18-073ARB-MPR – VESSELS’ RESIDENCE

Proposal

Construction of a new second-story addition over an existing single-story addition, a new single-story mudroom, and a new attached 1½-story, 3-garage and recreation room.

18-073ARB/MPR
Minor Project Review
63 S. Riverview Street

b. Mudroom

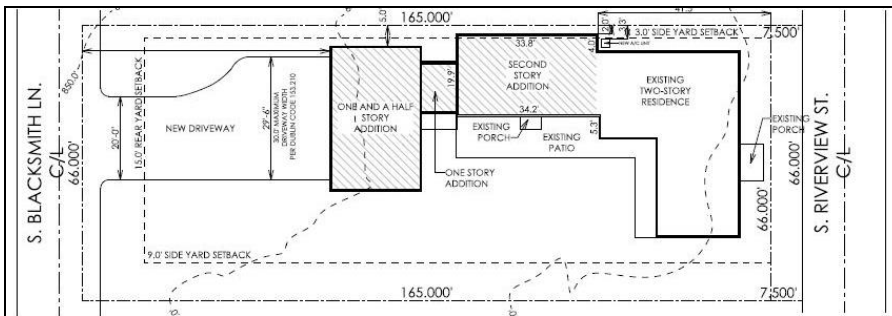
No changes have occurred to the mudroom design since the ARB's November review. The proposed mudroom is a one-story addition, which connects the main residence to the garage. Architecturally, the simplicity and scale of the structure provide relief to the overall design. The exterior is proposed to be finished in a stone veneer to match the modifications on the existing two-story structure, with windows, door, and metal roof to also match the proposed exterior modifications.

South Elevation – December 2018

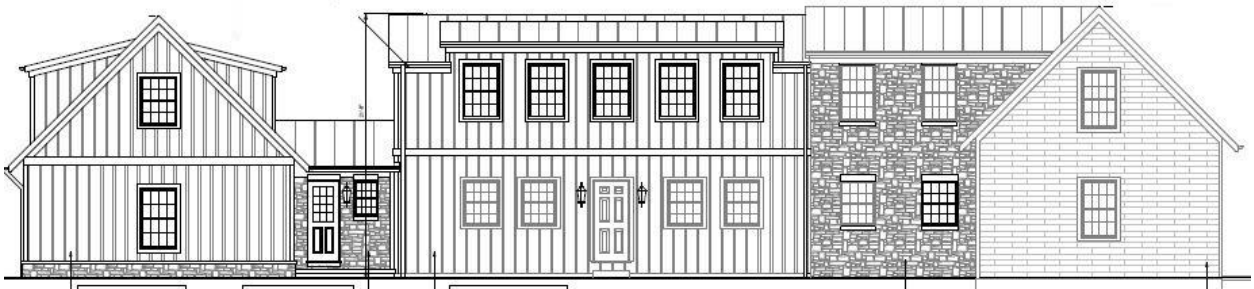
The design is simplified based on the November ARB comments by eliminating the faux gable on the south façade, streamlining the center section with a single gable, limiting the shed dormers to the north and south roofs, and creating a symmetrical window pattern on the south façade. The applicant has addressed all the Board's comments with the modified design.

In detail, construction of a 680-square-foot second-story addition is proposed over the 1-story addition located to the rear of the existing 2-story addition. The height of the second-story addition is 21-foot 8-inches which when compared to the existing 1½ story historic building (22-foot 3-inch height) is 5 inches shorter; and, 3 inches short than proposed in November, 2018.
